Model: Multi-Folding Unit FD5000		Date: 12-Jun-09	No.: RD454001
Subject: Correct procedures for pulling out inner folding unit / Grip modification		Prepared by: T.Tadokoro	
From: PPMC Service Planning Department 1G			
Classification:	<input type="checkbox"/> Troubleshooting <input type="checkbox"/> Mechanical <input type="checkbox"/> Paper path <input type="checkbox"/> Product Safety	<input type="checkbox"/> Part information <input type="checkbox"/> Electrical <input type="checkbox"/> Transmit/receive <input checked="" type="checkbox"/> Other (      )	<input checked="" type="checkbox"/> Action required <input type="checkbox"/> Service manual revision <input type="checkbox"/> Retrofit information <input type="checkbox"/> Tier2

Model: Multi-Folding Unit FD5000 (D454)		Date: 16-Nov-10	No.: RD454003
Subject: Part Changes - Guide Plate		Prepared by: T. Komori	
From: PP Service Planning Department 1G			
Classification:	<input type="checkbox"/> Troubleshooting <input checked="" type="checkbox"/> Part information <input type="checkbox"/> Action required <input type="checkbox"/> Mechanical <input type="checkbox"/> Electrical <input type="checkbox"/> Service manual revision <input type="che

Figure 1

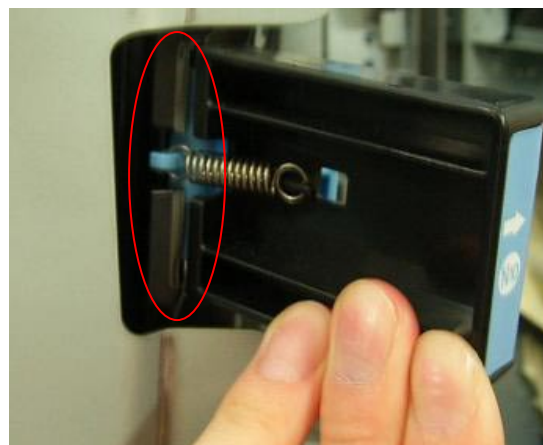
To pull out the folding unit, the Pre-stack Guide Plate (attached with Decal N10) requires a "clinch" as seen on Decal N10 (figure 1). When forced to open without the "clinch", the Pre-stack Guide Plate Grip could bend or even break (figure 2).

Along with thorough notification to customers of correct procedures for pulling out the unit, the Pre-stack Guide Plate Grip will be modified for improved durability. The modified Grip will be reflected from July - August production.

19.Fold Unit 13 (D454)

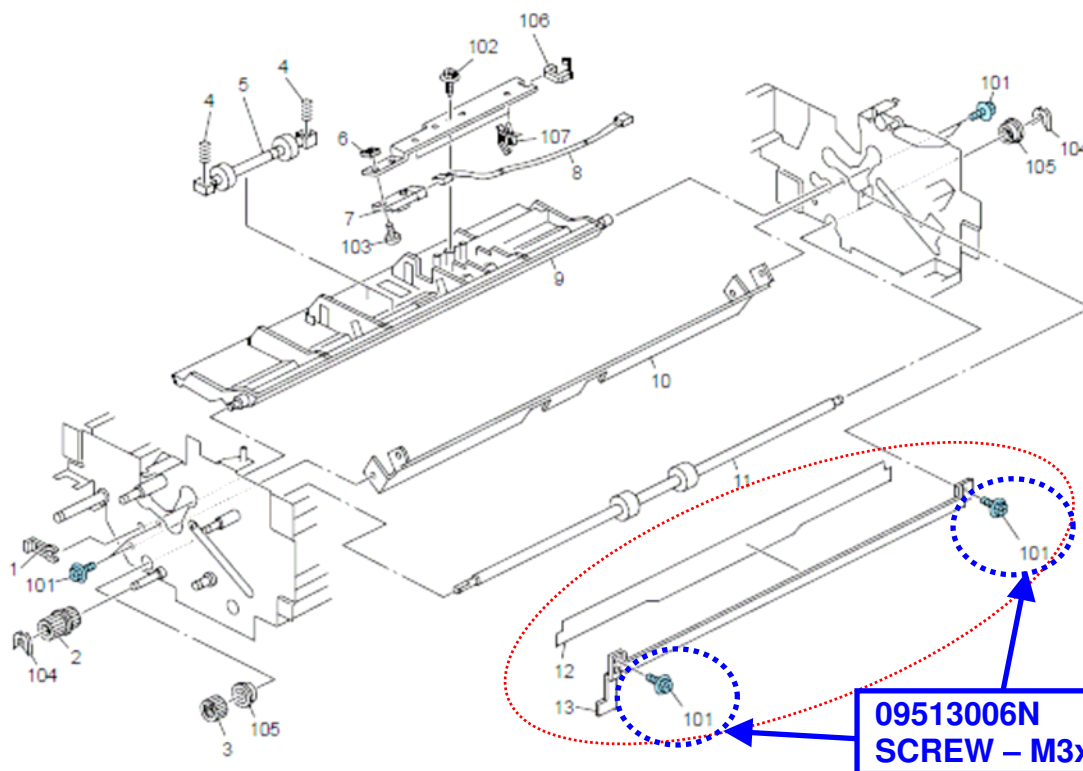
**Change:** Shape of the parts and screw types

**Reason:** To prevent misalignment of the brackets (D4554216 & D4554217) in the manufacturing process

Old Part Number	New Part Number	Description	Q'ty	Int	Page	Index	Note
D4553611	D4543615	GUIDE PLATE:NO.1	1	X/O	29	1	
D4544101	D4544105	PAPER CRIMP SUB-UNIT:NO.1:ASS'Y	1	X/O	31, 35	*	
D4544216	D4544218	GUIDE PLATE:NO.1:ENTRANCE	1	X/O	39	13	
D4544217	D4544219	SHEET:GUIDE:NO.1	1	X/O	39	12	
	09513006N	SCREW - M3X6	2		39	108	Add

## 12.Fold Unit 6 (D454)

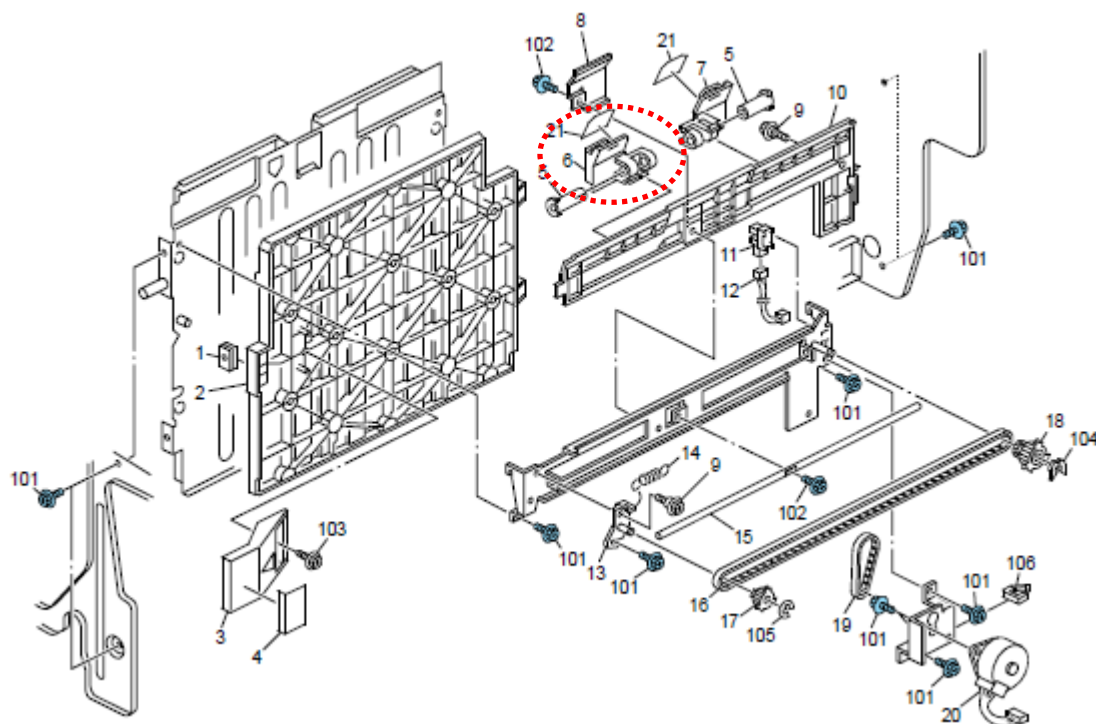
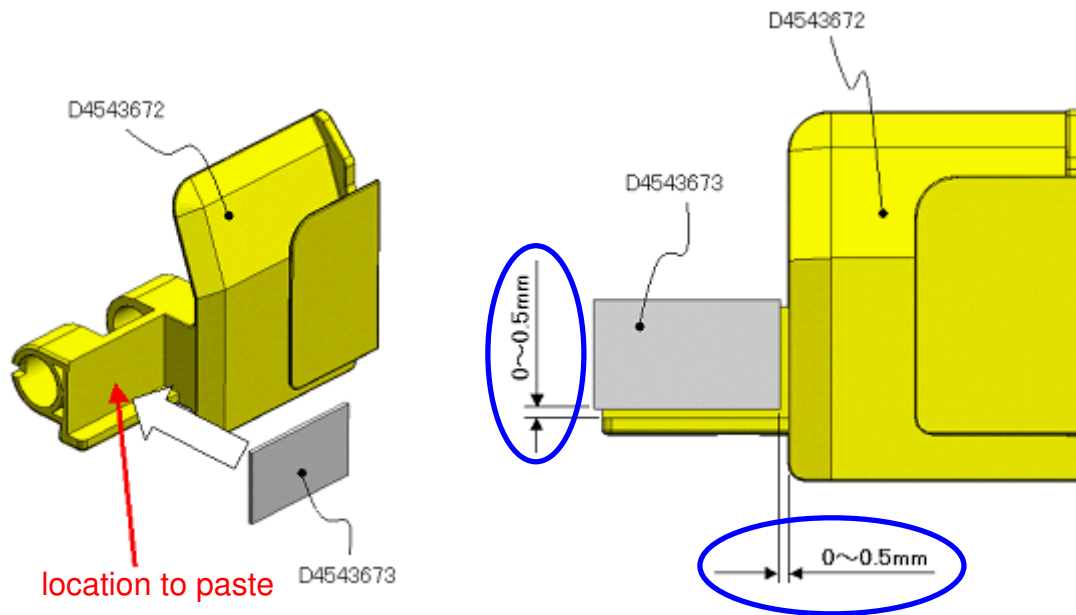
**Change:** Part was added

**Reason:** To prevent the paper detection sensor from falsely detecting the jogger fence

A pad has been added to the jogger fence to optimize the distance between the paper detection sensor and the jogger fence which will give a larger margin of error.

Old Part Number	New Part Number	Description	Q'ty	Int	Page	Index	Note
D4543693	D4543672	JOGGER FENCE:FRONT	1	X/O	X/O as a set	25	6
	D4543673	PAD:SENSOR	1			25	22 Add

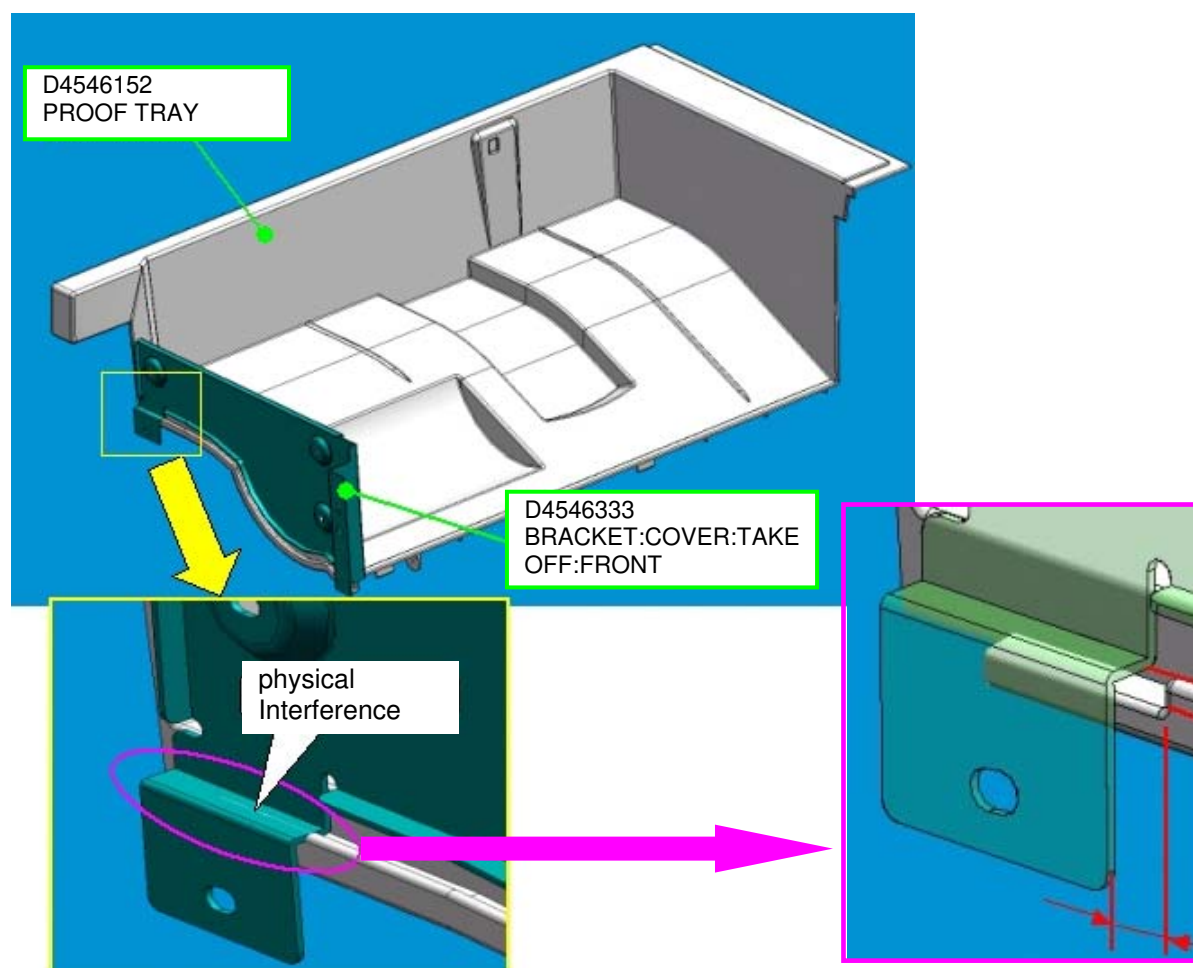
**Change:** Shape of the part

**Reason:** As a result of the bracket modification (D4546332 → D4546333), interference occurred as shown in the following diagram. This modification is to standardize for releasing Multi-Folding Unit FD5010.

Tray's shape has been changed.  
(D4546152 -> D4546153)

Old Part Number	New Part Number	Description	Q'ty	I/C	Page	Index
D4546152	D4546153	PROOF TRAY	1	X/O	59	4
D4546332	D4546333	BRACKET:COVER:TAKE OFF:FRONT	1	X/O	3	8

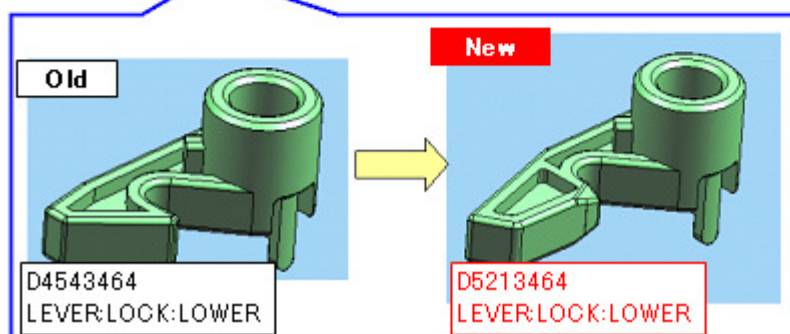
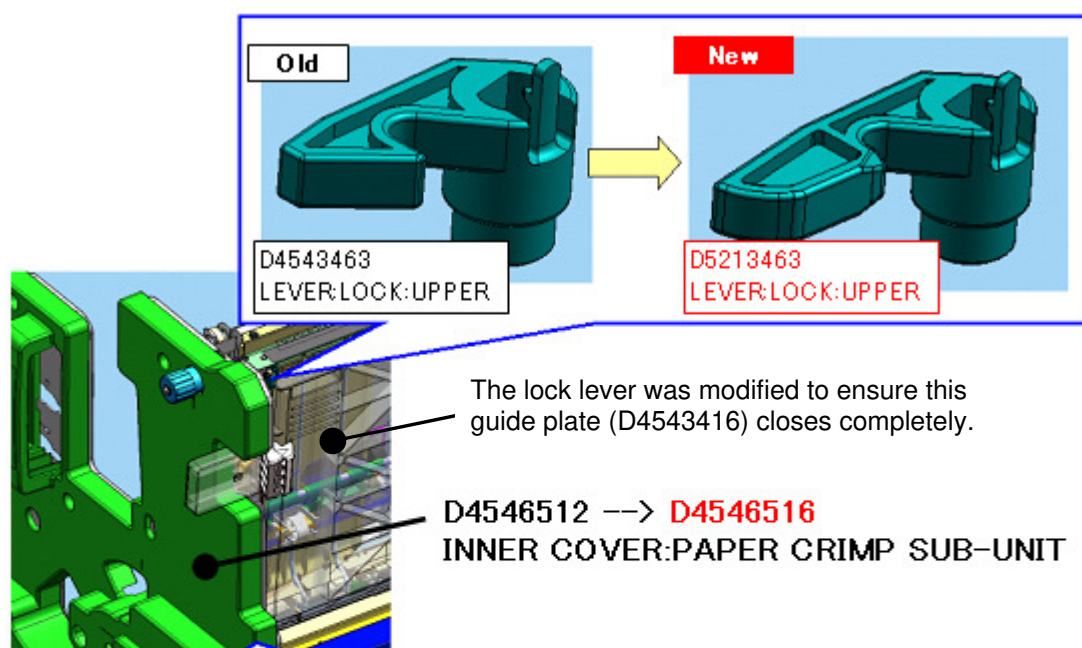
**Change:** Shape of the lock lever

**Reason:** To ensure complete shut of the guide plate to prevent possible jams

Old Part Number	New Part Number	Description	Q'ty	Int	Page	Index	Note
D4543463	D5213463	LEVER:LOCK:UPPER	1	X/O	as a set	17	20
D4543464	D5213464	LEVER:LOCK:LOWER	1	X/O		17	21
D4546512	D4546516	INNER COVER:PAPER CRIMP SUB-UNIT	1	X/O		15	6

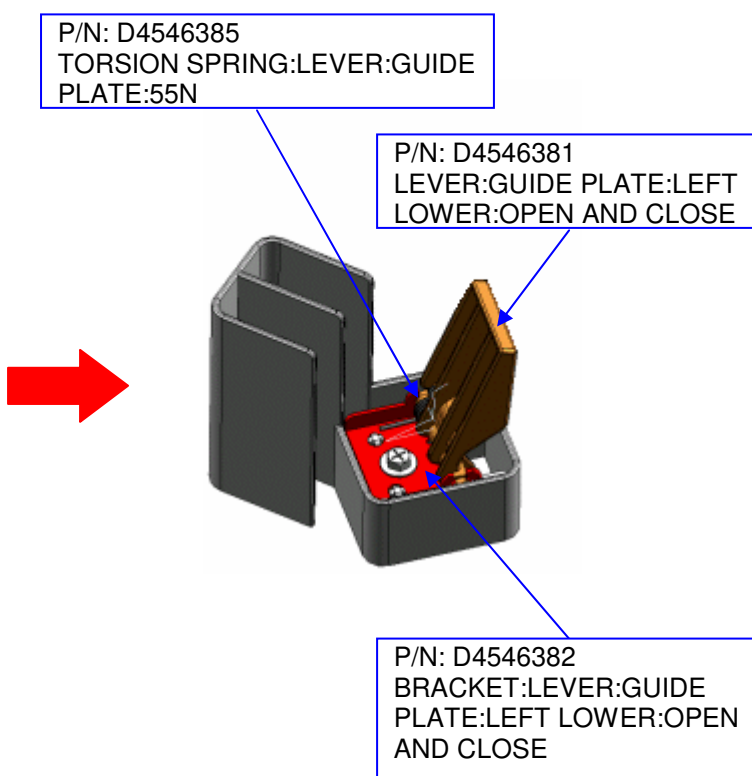
**Change:** The following parts were added as service parts.

**Reason:** To increase magnetic strength for secure closing of the door.

Old Part Number	New Part Number	Description	Q'ty	Int	Page	Index	Note
-	D4546381	LEVER:GUIDE PLATE:LEFT LOWER:OPEN AND CLOSE	1	-	3	22	Add
-	D4546382	BRACKET:LEVER:GUIDE PLATE:LEFT LOWER:OPEN AND CLOSE	1	-	3	23	Add
-	D4546385	TORSION SPRING:LEVER:GUIDE PLATE:55N	1	-	3	24	Add

22.Fold Unit 16 (D454)

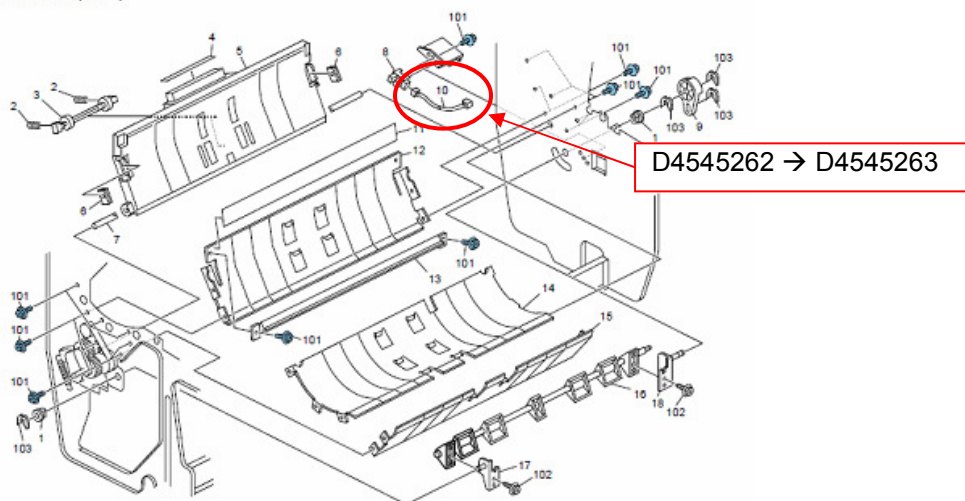
**Change:** P/N modification of the motor cover and harness

**Reason:** To allow application of common parts with the Multi-Folding Unit FD5010

Old Part Number	New Part Number	Description	Q'ty	Int	Page	Index	Note
D4544419	D4544422	COVER:DC MOTOR:NO.1	1	X/O	55	21	-
D4545262	D4545263	HARNESS:SENSOR:PULL OUT:SENSOR	1	X/O	45	10	-

When replacing the above parts for the first time, replace as a set.
